Amendments to the Drawings:

REMARKS

FIG. 3

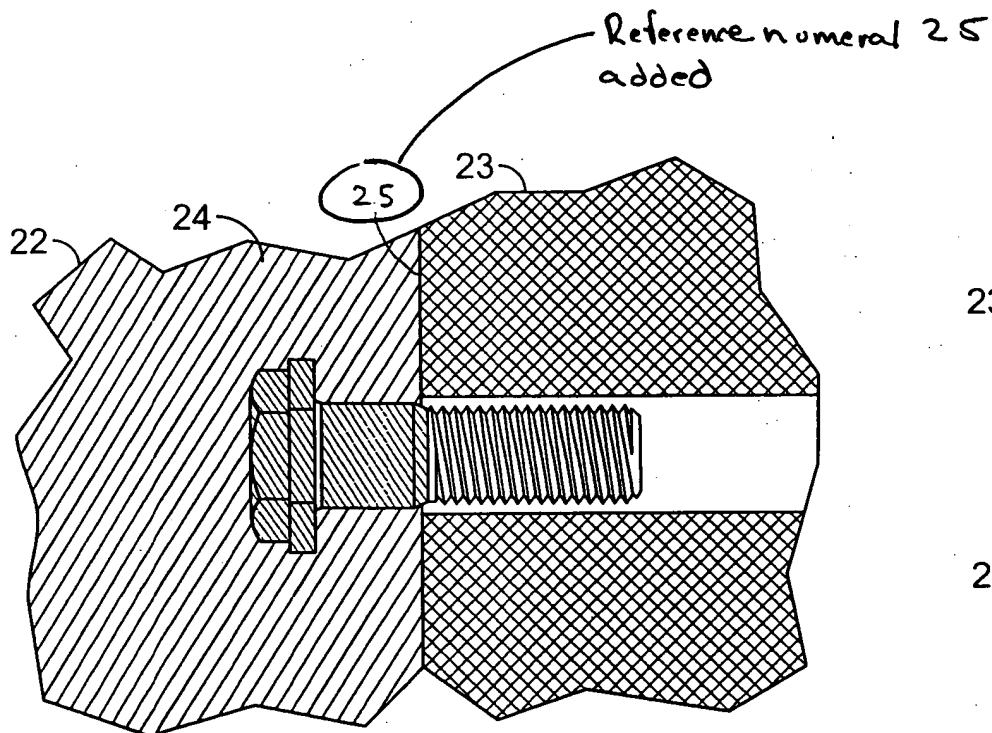
The attached sheets of drawings are formal drawings of the drawing figures previously submitted and include changes to Fig. 3. These sheets, which include Figs. 1-4, replace the original drawing sheets including Figs. 1-4. In Fig. 3, Applicants have added reference numeral 25.

In the Office Action dated June 7, 2005, the Examiner objected to the drawings under 37 C.F.R. 1.83(a) because the Examiner believed that a “battery cell” was not shown in the drawings and because the drawings were informal. By the above amendment, the Applicants have submitted formal drawings and have amended the claims to delete the stand-alone term “battery cell” and therefore respectfully request that the examiner withdraw the objections to the drawings.
